Product Change Notice (PCN)

PCN Number: PCN-0450921R-01

Product(s) Affected:
SJ-43514-SMT-TR, SJ-43515RS-SMT-TR, SJ-43515TS-SMT-TR, SJ-43516-SMT-TR, SJ-43516-SMT-TR-BE, 43516-SMT-TR-GR, & 43516-SMT-TR-PI

1. Minor housing, terminal size differences

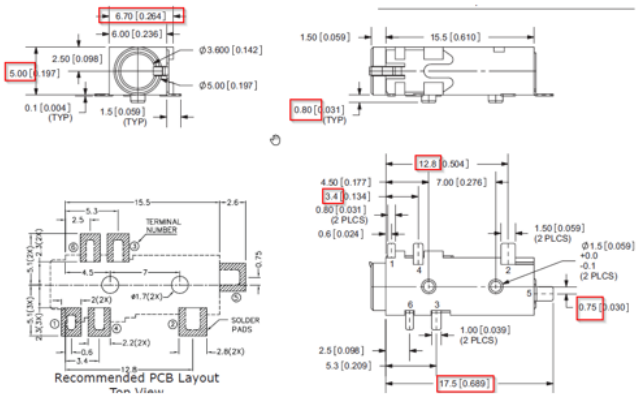
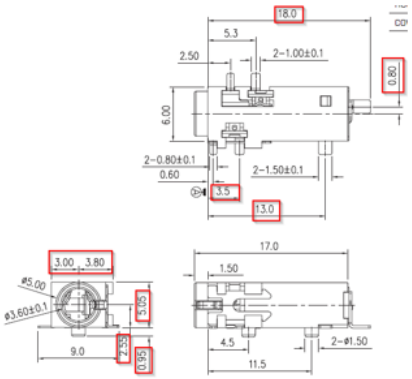
PREVIOUS CUI DEVICES DETAIL / IMAGE	NEW CUI DEVICES DETAIL / IMAGE

2. PCB size differs

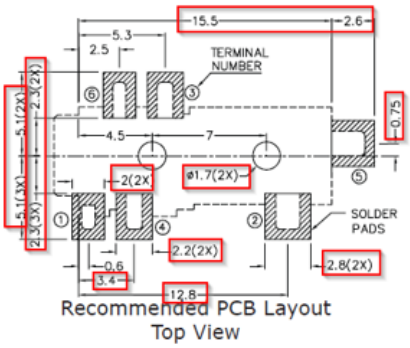
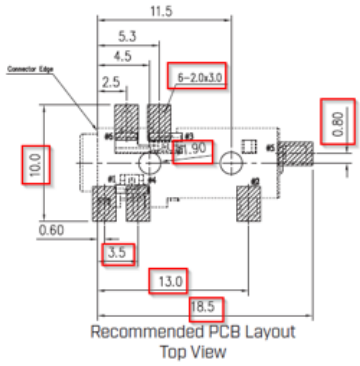
PREVIOUS CUI DEVICES DETAIL / IMAGE	NEW CUI DEVICES DETAIL / IMAGE

5. Tape and reel packaging differs

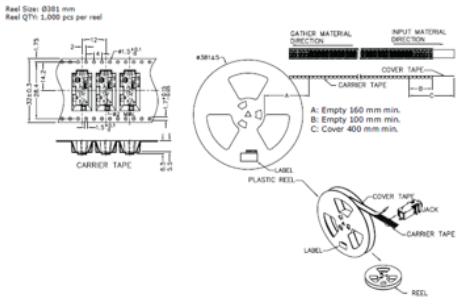
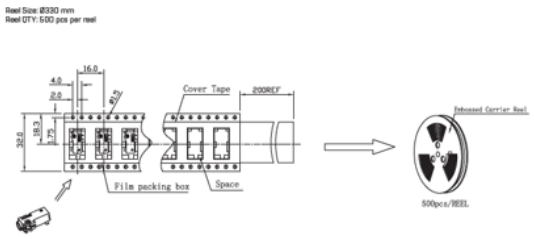
PREVIOUS CUI DEVICES DETAIL / IMAGE	NEW CUI DEVICES DETAIL / IMAGE
